Derby Silk Mill

CAAC Presentation

April 2017

HLF Stage 2

Front Roof Modelling

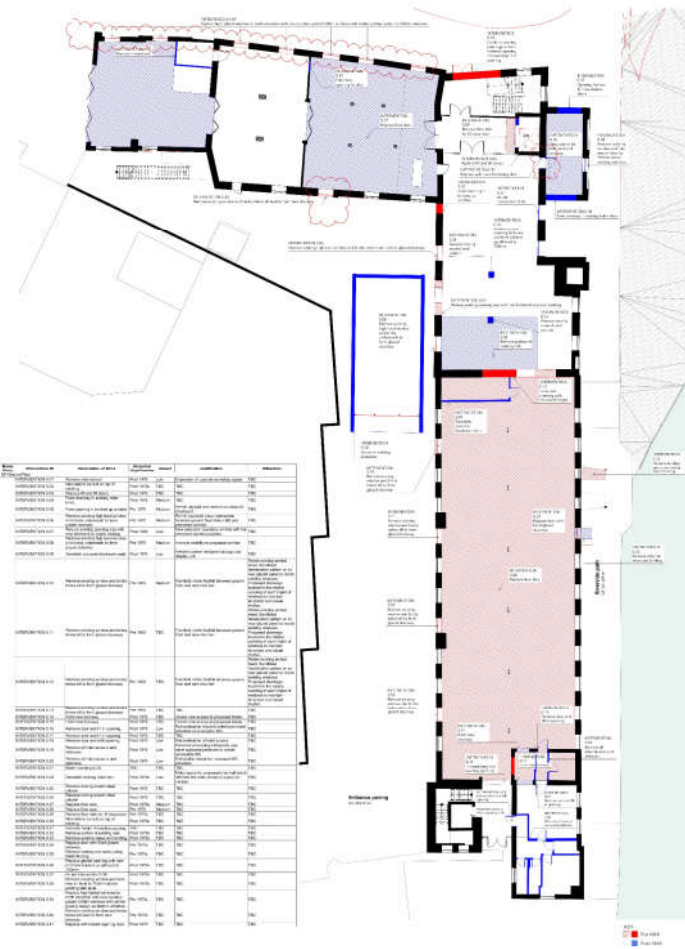
Front Roof Remodelling	modelling of roof less extensive that discussed with Penny previously. Tried to do the minimal thing that works with the existing geometry. Required in order to get the lift and stair up to the third floor attic space and access up to the tower to create a viewing platform which is seen as a benefit. There needs as a minimum a corridor to come out of the side of the tower at third floor level from the lift and stair		Some concern on impact and discussion on need	Further justification to be provided together with other options and an indication of the minimum space that is required.		
Rear Toilet Remodelling and Extension	Rear toilet block 60s or 70s inelegant and poor windows. Poor thermal performance as well. Need to extend the lift overrun so as to serve the fourth floor and provide more toilets so that we can provide adequate facilities but not have to sub divide internal volumes and loose character. This would extend the volume above the current eaves level. Proposal to clad the structure and externally insulate and rationalise the windows to reflect the new internal arrangement.		Concern on extending the volume above the eaves line and the idea of over cladding it so that it might compete with he original fabric. Prefer to replace windows but not make it any more noticeable	Further justification required as to why this is the sensible place to have toilets and why there are needed. Reconsider the over cladding.

First and Second Floor Slab Replacement

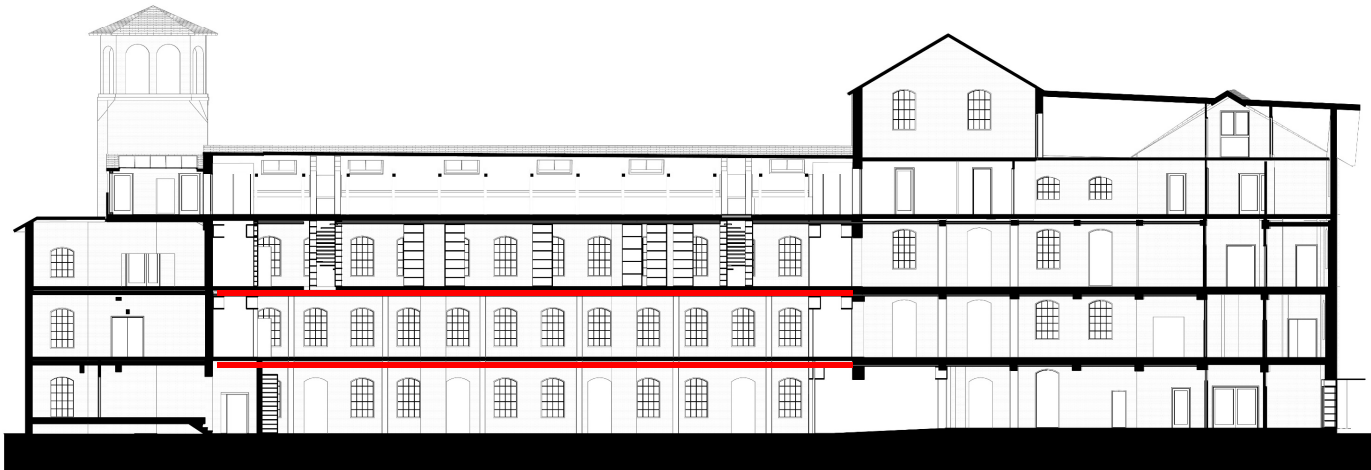
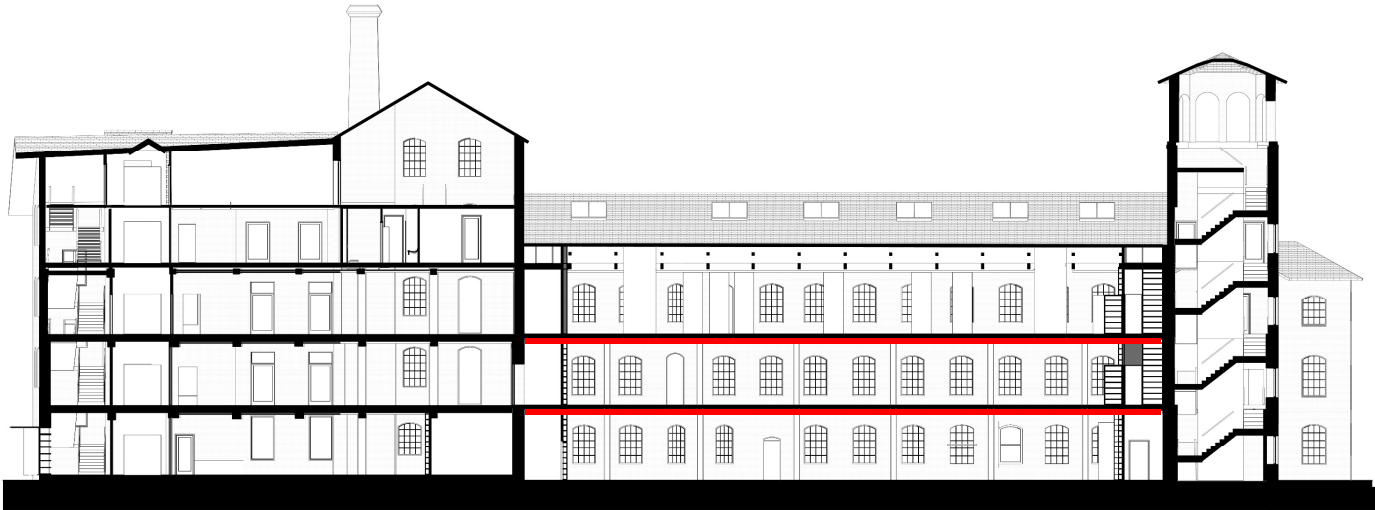
Intervention	Narrative/ Proposal	Issues raised in Historic England letter of 16th December 2016	Issues Raised in Meeting on 9th February	Actions Required	Comments By HE	Comments By DCC Conservation Officer
Ground Floor Slab Replacement	Floor needs to be replaced as reinforcement below is exposed and slab is failing structurally. Replacement slab will be at same level with 280mm concrete upstands around external walls to create an effective flood defence level to equal that in the rest of the mill. Impractical and big impacts on the historic fabric to raise height of slab in rest of mill. Will achieve a 1:40 year flood event protection.		No particular issues	No specific further justification required		
First & second Floor Slab Replacement	Concern that second floor slab will not be capable of loading required for the museum accessible store areas. Downstand beams below slab cause issues with elegant servicing strategy- servicing would have to be below lowest beam further restricting the height of the space and looking visually cluttered. Slabs both have been replaced sometime after the 40's from the 1910 timber floor. Floor levels in the mill generally have changed over the years. Proposal is to replace the slab at first and second floor level with a new structure that will have the steel within the depth of the slab. Still see the structure exposed on the underside of the slab. Servicing can be incorporated into flat soffit- lack of visual clutter and restriction on headroom in space. Suggest replacing slab at 280mm higher than existing so that there are no temporary propping works and floor level in Italian Mill is the same as rest of mill.		No specific objection or support. Went to see the slabs after the meeting on the walk around	BLA to provide a design narrative
